[REDACTED]
[REDACTED] - Brake Pedal Rework

7/18/18

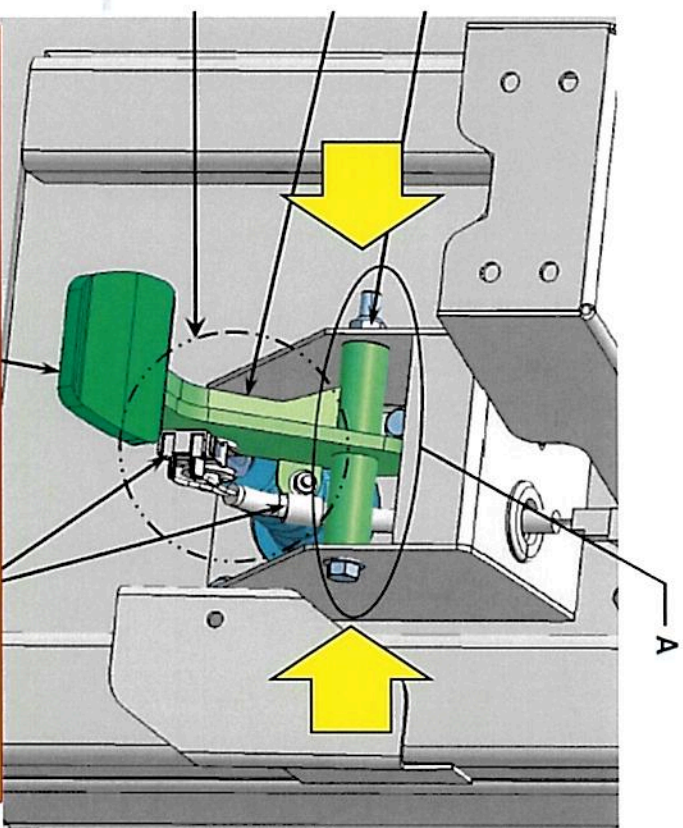
Insert 1 pcs of washer
23-09114-025 on
passenger side of pedal
mounting

Torque pivot bolt to 30 ft./lbs.
After brake pedal is tight, ensure
small amount of left to right
movement on the pivot tube

DETAIL A - EXPLODED FOR CLARITY

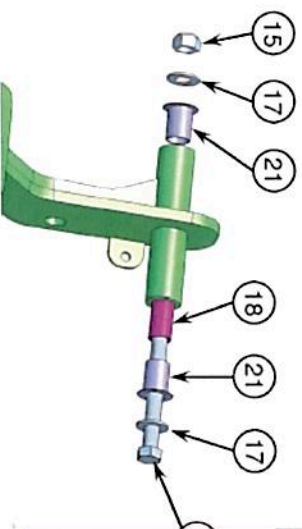
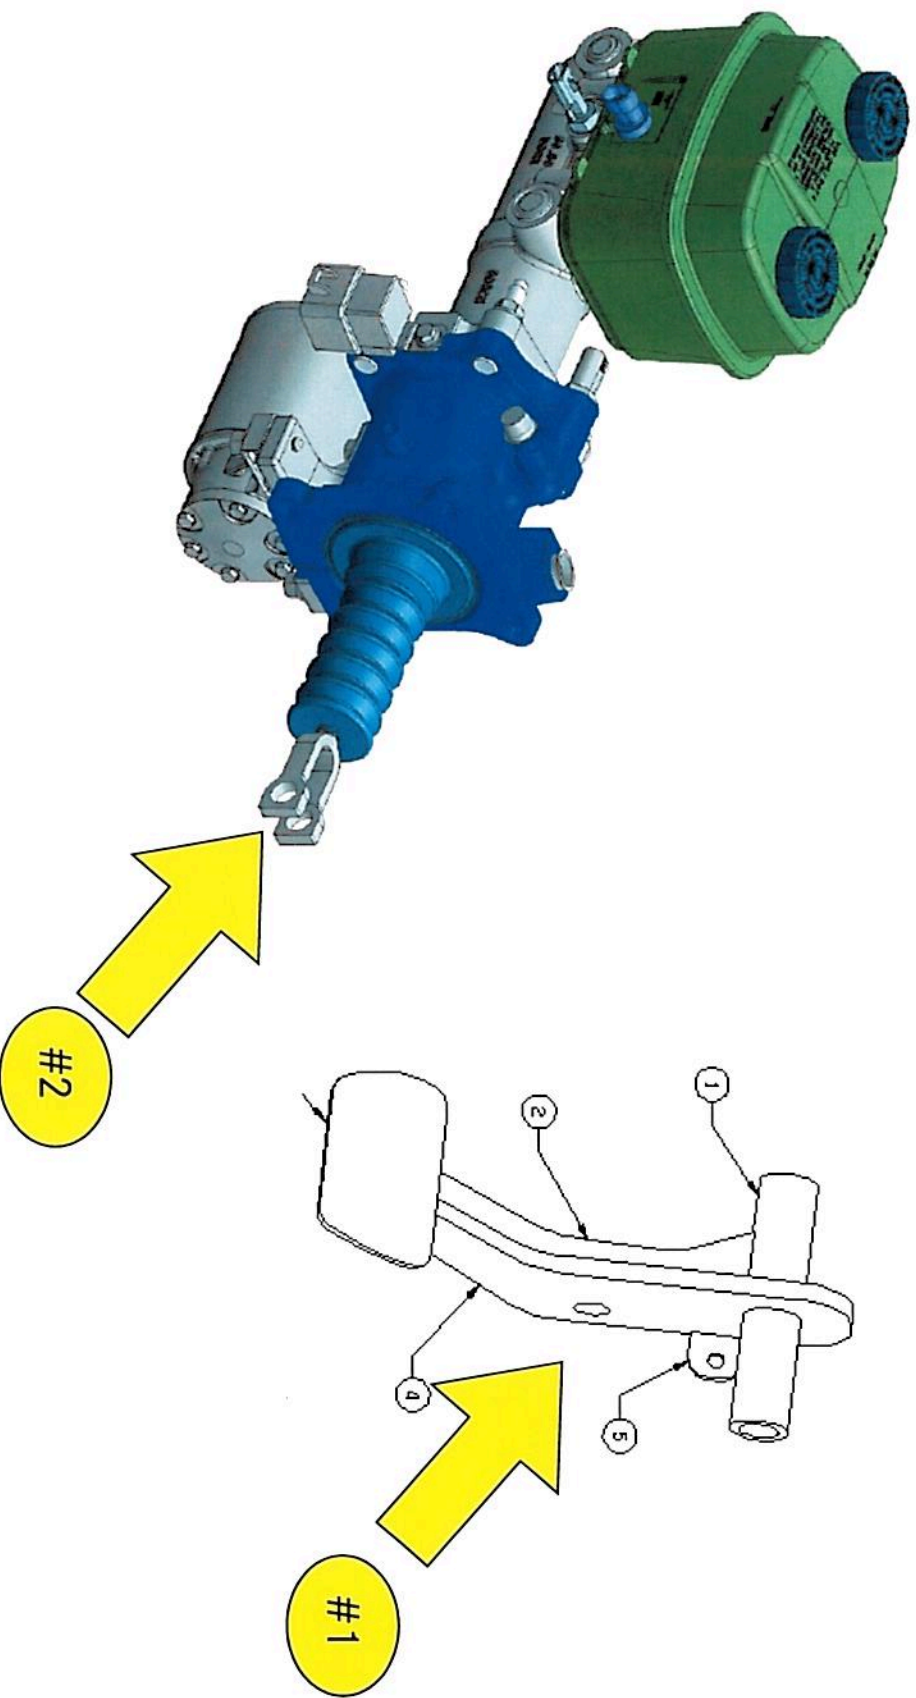
Ensure pedal (#1) is in center of yoke (#2) prior to installing the brake switch
